**ADDENDUM NO. 2  
TO THE  
BIDDING REQUIREMENTS AND CONTRACT DOCUMENTS  
FOR THE  
DIV IV DRY WEATHER PUMP STATION AND FORCE MAIN REHABILITAITON**

**OWNER:** **City of Anderson**

**ISSUED BY/ENGINEER:** Egis Group  
8320 Craig Street  
Indianapolis, Indiana 46250

**ISSUE DATE:** December 24, 2025

**SECTION A-A**

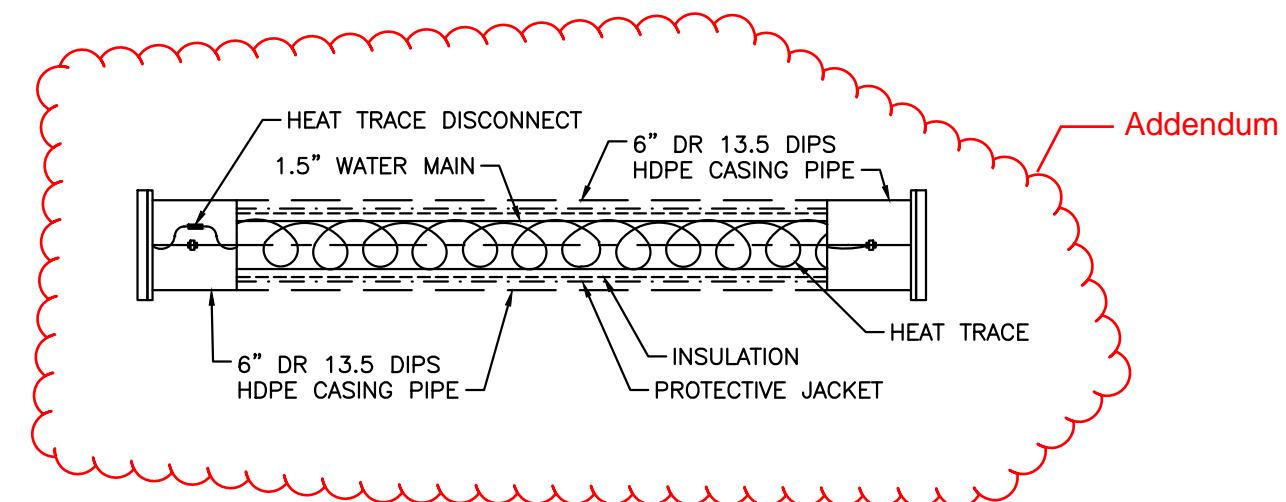
- A. Sheet C107 – Additional details have been added to Sheet C107.
- B. Sheet I106 – Additional information has been added to Sheet I106.

**BYPASS PUMPING PLAN**

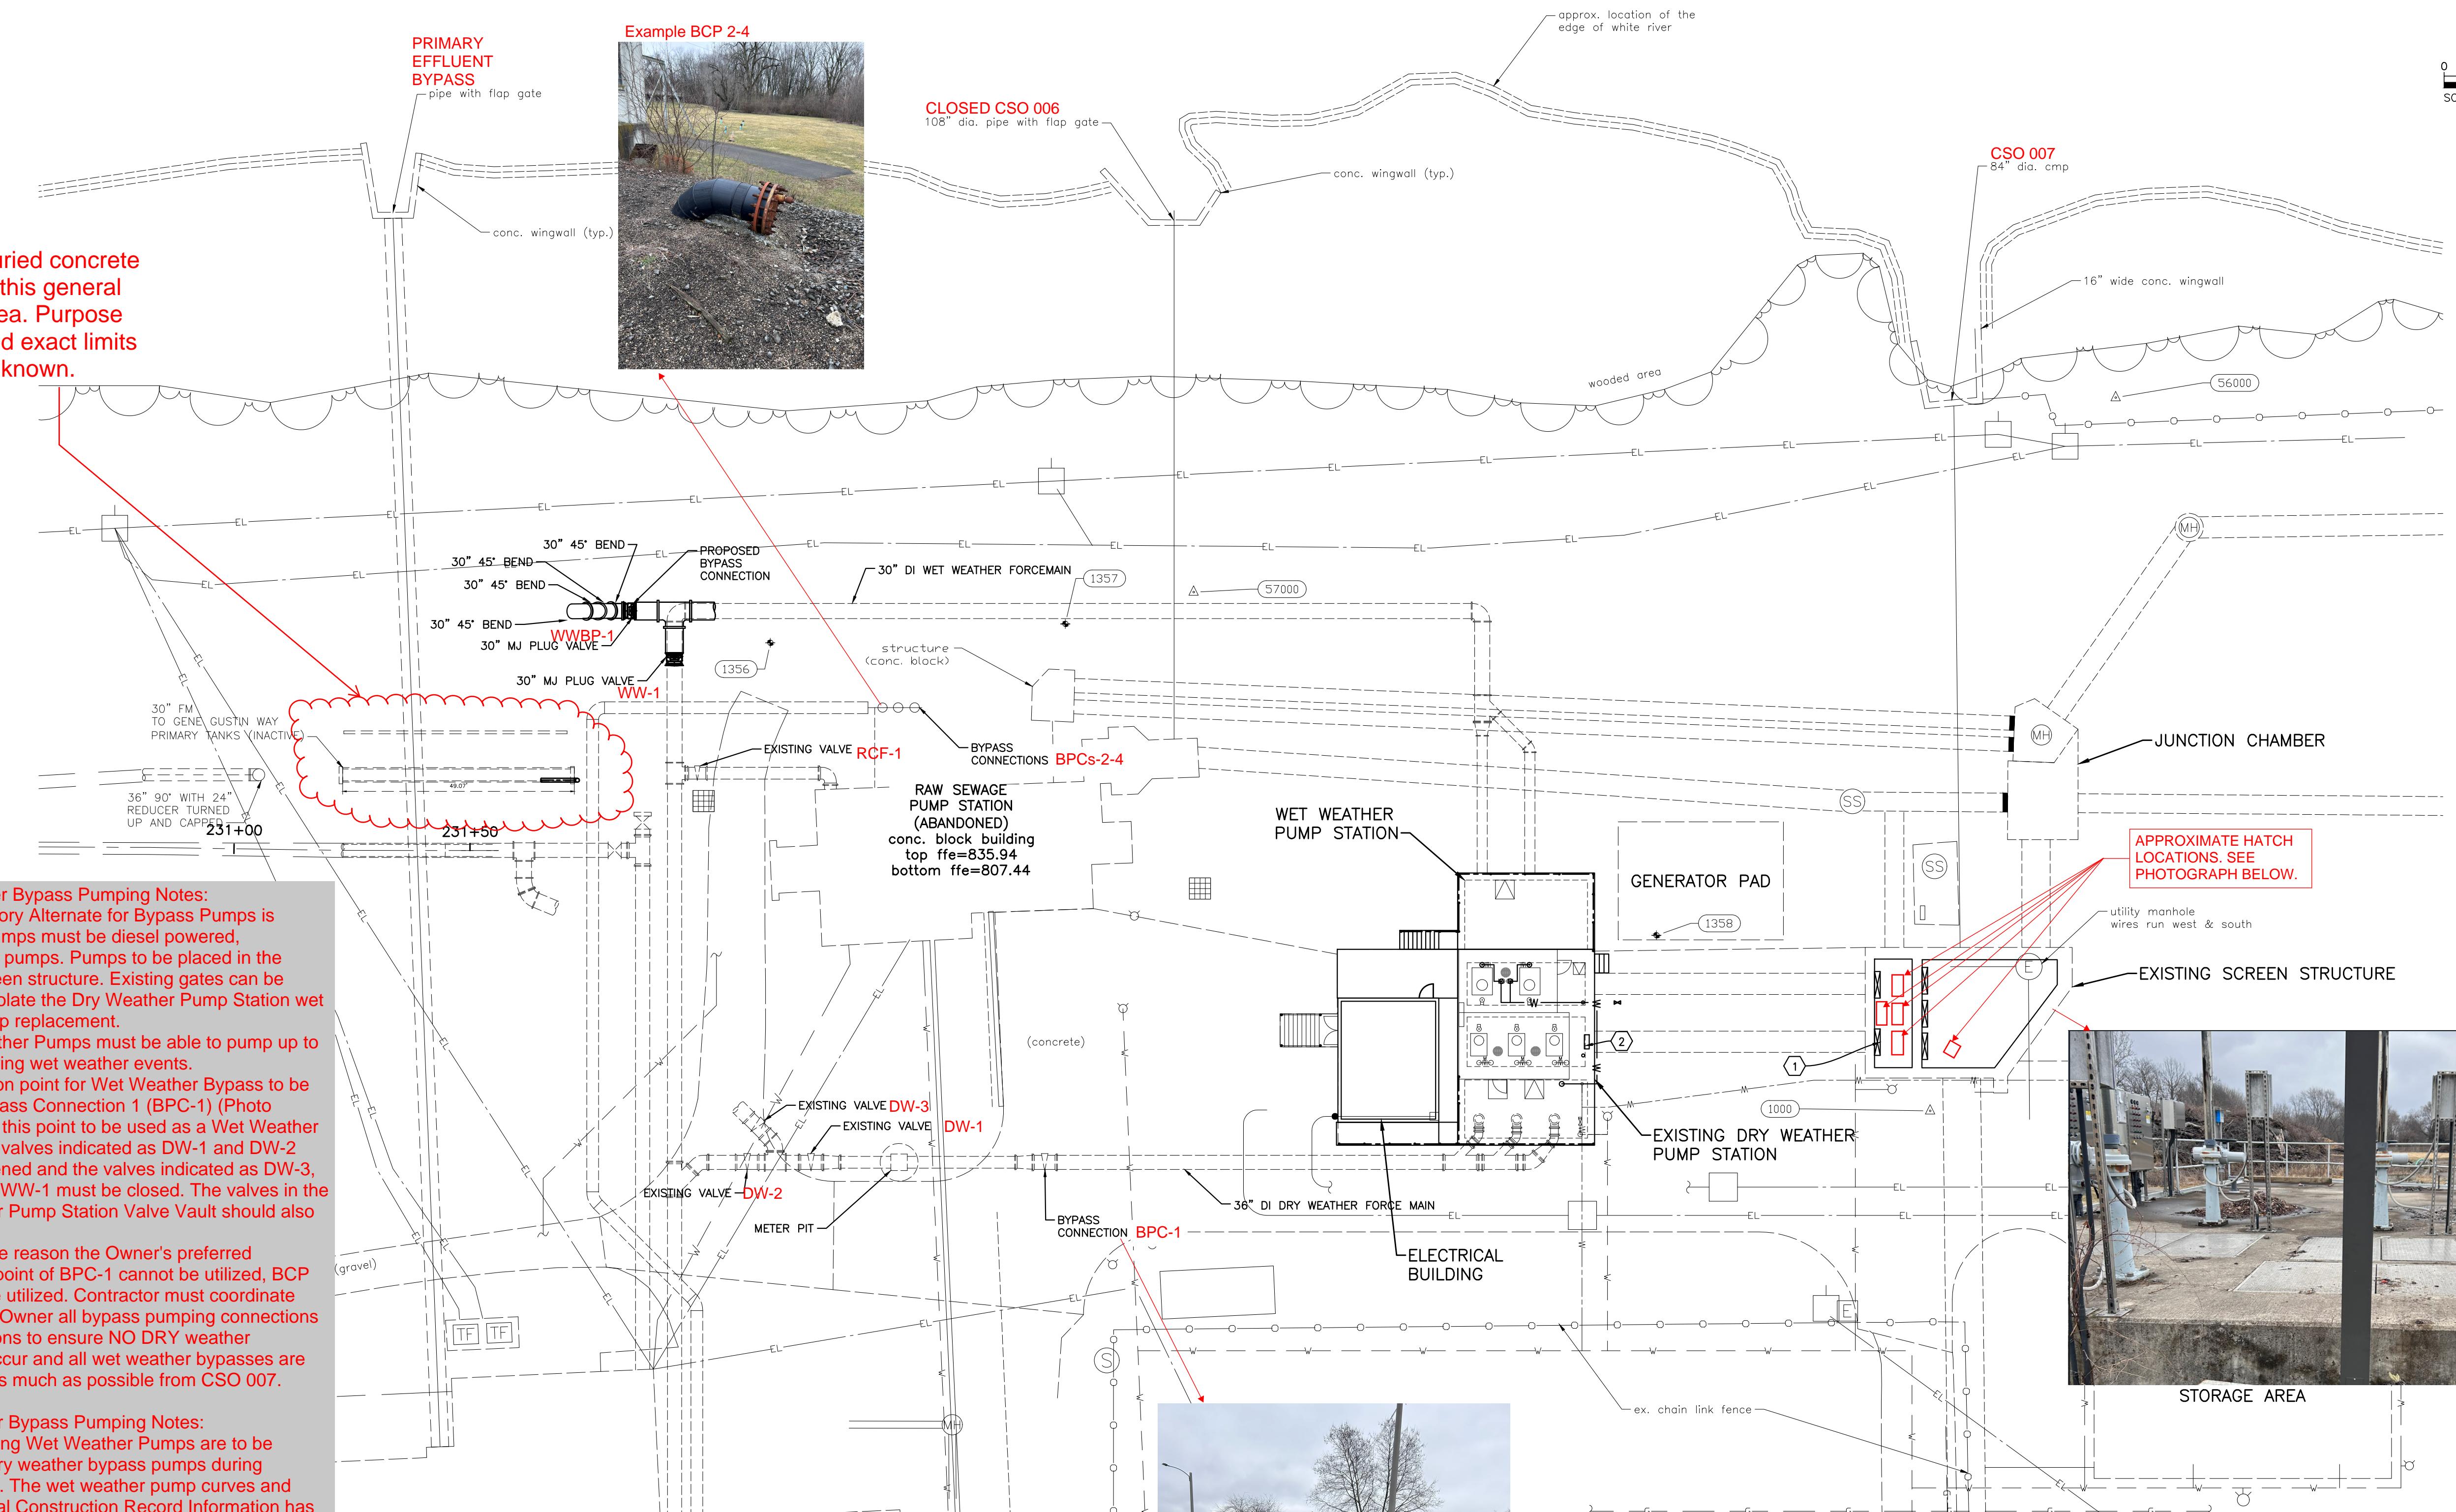
- A. Sheet C108 – Bypass Pumping Plan – This sheet is added to include additional information in support of the Mandatory Alternates 3, 4, and 5.
- B. Sheet E104A – Dry Weather Pump Station Electrical One-Line Diagram – New – This sheet has been added to the plan set.

*Response: See sheet C108. All questions should be answered with information provided on that sheet.*

*Response: Please refer to added sheet C108. If Mandatory Alternate Number 5 (MA #5) is selected, the Contractor would provide the equipment and piping to meet the requirements included in the Bypass Pumping specification and C108. If the Alternate is not selected, the Owner will be providing all items associated with MA #3.*

*Response: Please see added sheet C108.*

EXISTING 480V SWITCHGEAR SWGR-1  
FRONT ELEVATION  
NOT TO SCALE

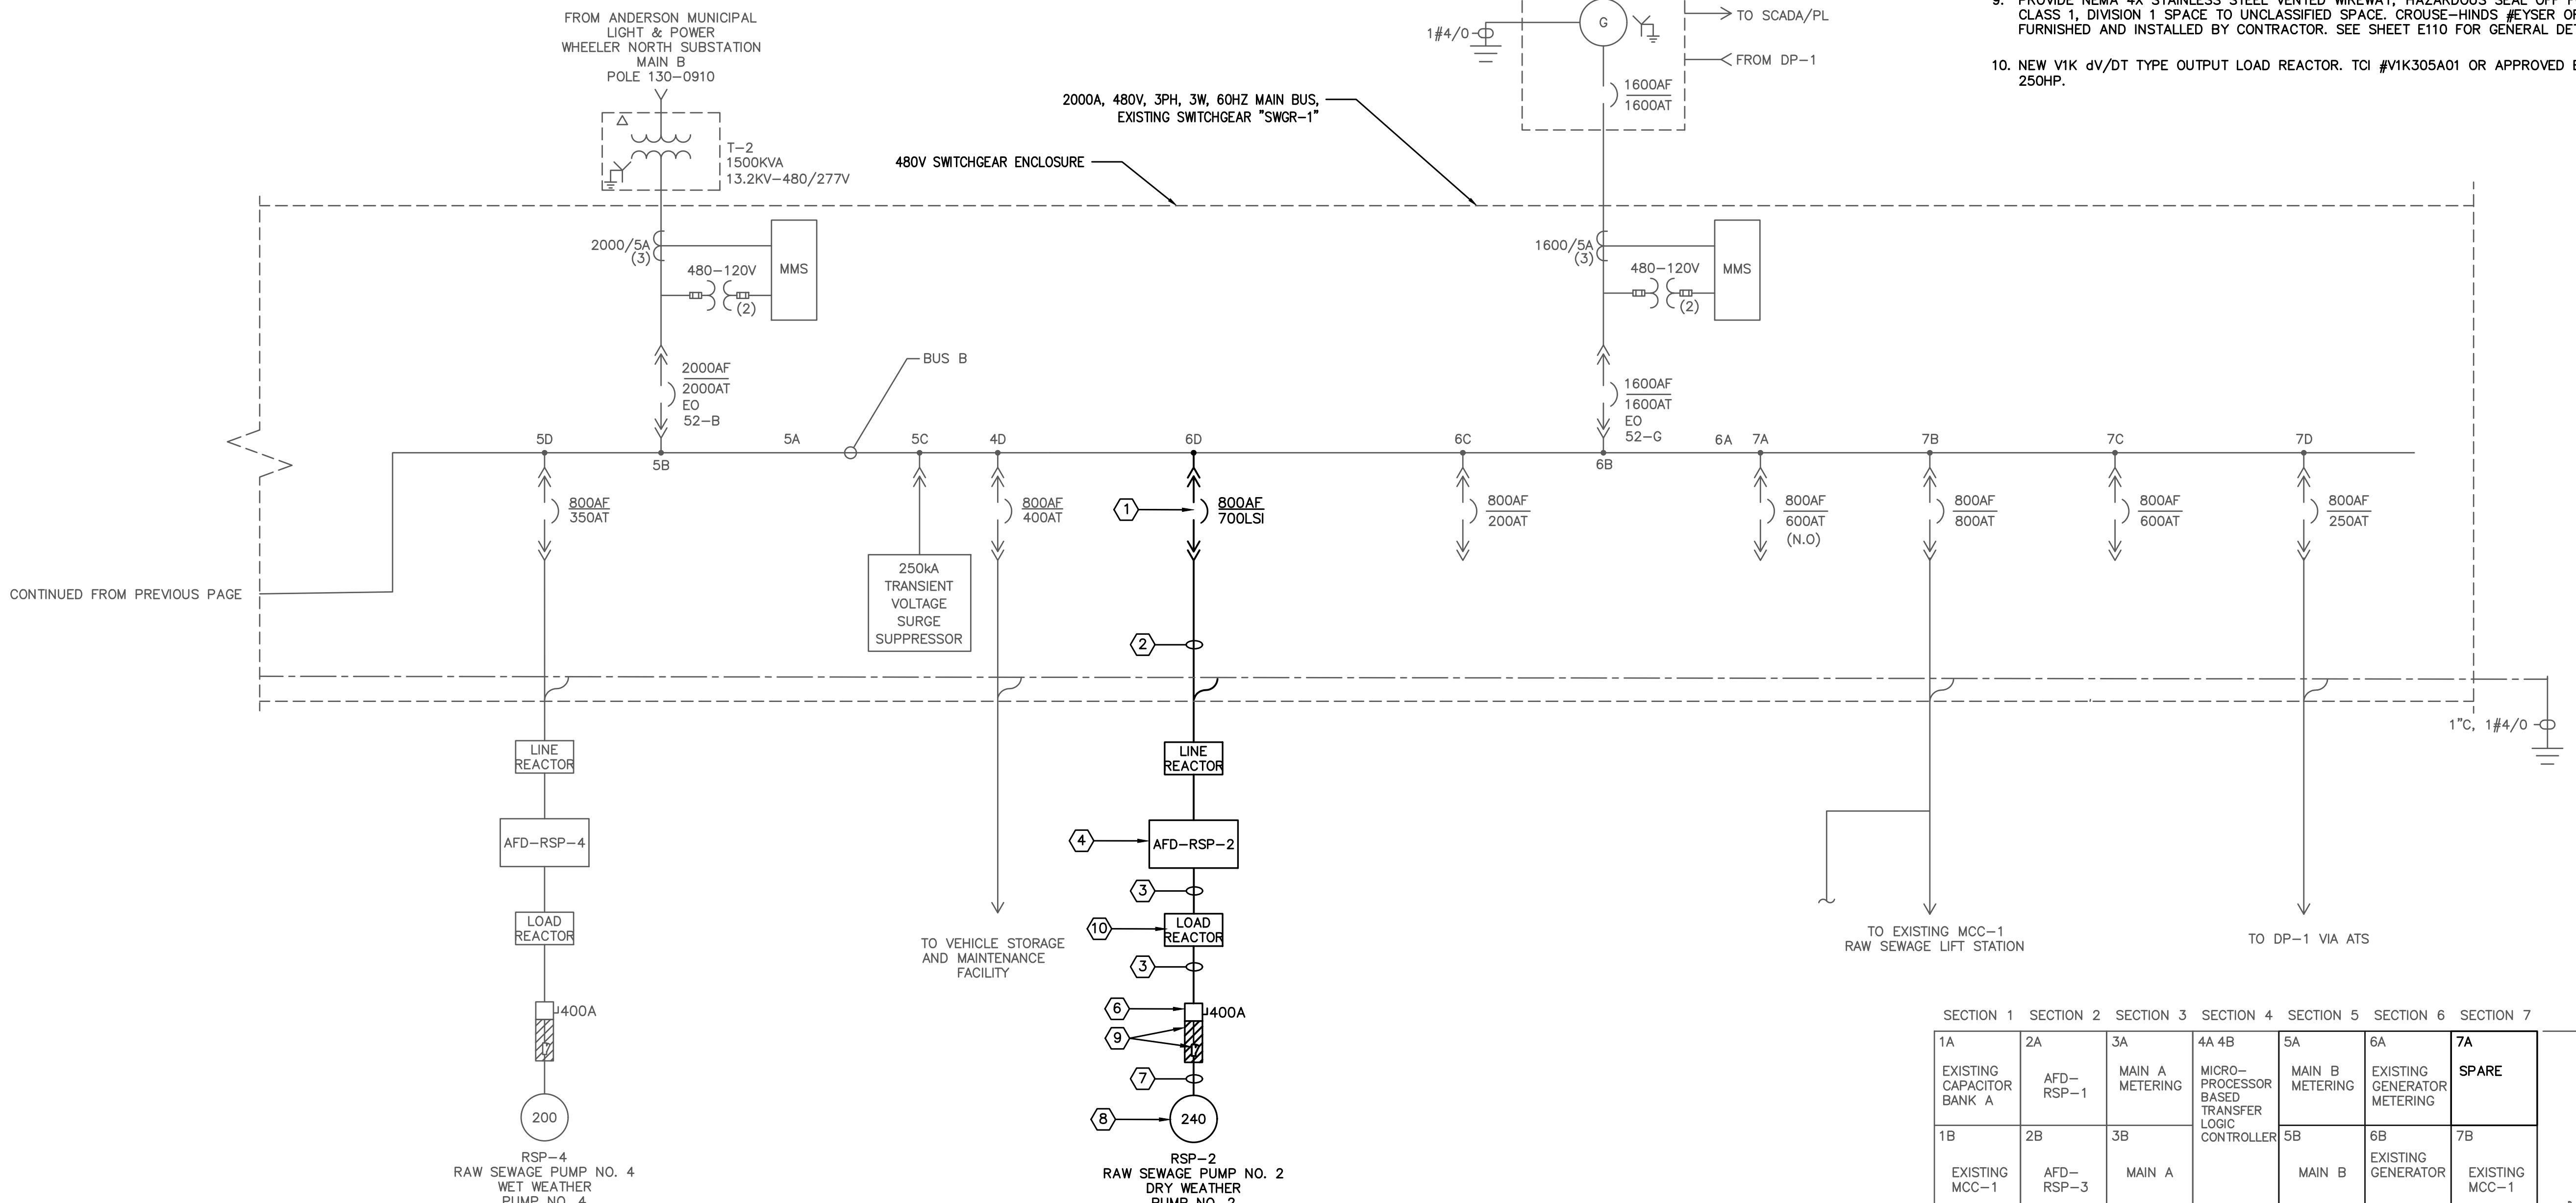
- D. Sheet E104A – Dry Weather Pump Station Electrical One-Line Diagram – New – Clarification to the Existing 480V Switch Gear SWGR-1 Front Elevation. Area 6D should have been marked with keynote 1 and area 7C should have been labeled “Spare”.
